# Access Compliance Report

## Public Rights-of-Way

### (Pedestrian Signals)

Intersection ID: N/A	Main Street:	Cross Street: N/A	Location: N/A
ADA ID: 6CAE690CDD6D	Signal Type: One Push Button-Non APS	Overall Compliance: No	Severity Score: BTN 1: N/A BTN 2: N/A No BTN: N/A
Codes/Mitigation Info/Possible Solution		Field Measurements/Component Compliance

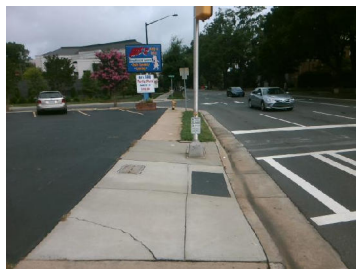
PROW/ADA: R404.2, R404.3, R406.2

Compliance	Description	Data	Compliance	Description	Data
	Button Count	Button1	N/A	Distant to Additional Button (in)	N/A
	Additional Button Present?	No		Additional Button ID	N/A
N/A	Signal Buttons Required?	N/A	N/A	Additional Ped Posts Required	N/A
	How Many Ped Street Xings?	1		Located In An Island/Median?	No
N/A	B 1 Sign Present?	Yes	N/A	B 2 Sign Present?	N/A
Yes	B 1 Sign Purpose?	Yes	N/A	B 2 Sign Purpose?	N/A
Yes	B 1 Sign Lettering & Contrast?	Yes	N/A	B 2 Sign Lettering & Contrast?	N/A
Yes	B 1 Parallel To XWalk?	Yes	N/A	B 2 Parallel To XWalk?	N/A
Yes	B 1 PAR to Button?	Yes	N/A	B 2 PAR to Button?	N/A
Yes	B 1 PAR to XWalk?	Yes	N/A	B 2 PAR to XWalk?	N/A
Yes	B 1 Clear Floor Space?	Yes	N/A	B 2 Clear Floor Space?	N/A
N/A	B 1 FWD Approach?	Yes	N/A	B 2 FWD Approach?	N/A
N/A	B 1 FWD Approach Constrained?	No	N/A	B 2 FWD Approach Constrained?	N/A
No	B 1 FWD Approach Reach (in)	5.0	N/A	B 2 FWD Approach Reach (in)	N/A

N/A	B 1 FWD Approach Width (in)	N/A	N/A	B 2 FWD Approach Width (in)	N/A
N/A	B 1 FWD Approach Obstruction?	Yes	N/A	B 2 FWD Approach Obstruction?	N/A
N/A	B 1 FWD Approach Obstruction Dist (in)	5.0	N/A	B 2 FWD Approach ObstructionDist (in)	N/A
N/A	B 1 PARA Approach?	Yes	N/A	B 2 PARA Approach?	N/A
N/A	B 1 PARA Approach Constrained?	No	N/A	B 2 PARA Approach Constrained?	N/A
Yes	B 1 PARA Approach Reach (in)	5.0	N/A	B 2 PARA Approach Reach (in)	N/A
N/A	B 1 PARA Approach Width (in)	0.0	N/A	B 2 PARA Approach Width (in)	N/A
N/A	B 1 PARA Approach Obstruction?	Yes	N/A	B 2 PARA Approach Obstruction?	N/A
N/A	B 1 PARA Approach Obstruction Dist (in)	5.0	N/A	B 2 PARA Approach ObstructionDist (in)	N/A
No	B 1 Clear Floor Space Slope (%)	8.8	N/A	B 2 Clear Floor Space Slope (%)	N/A
No	B 1 Clear Floor Space XSlope (%)	5.8	N/A	B 2 Clear Floor Space XSlope (%)	N/A
N/A	B 1 PAR Slope (%)	8.6	N/A	B 2 PAR Slope (%)	N/A
Yes	B 1 Height (in)	41.0	N/A	B 2 Height (in)	N/A

Possible Solutions: Provide Push Button Extension. Remove and Replace Clear Space.
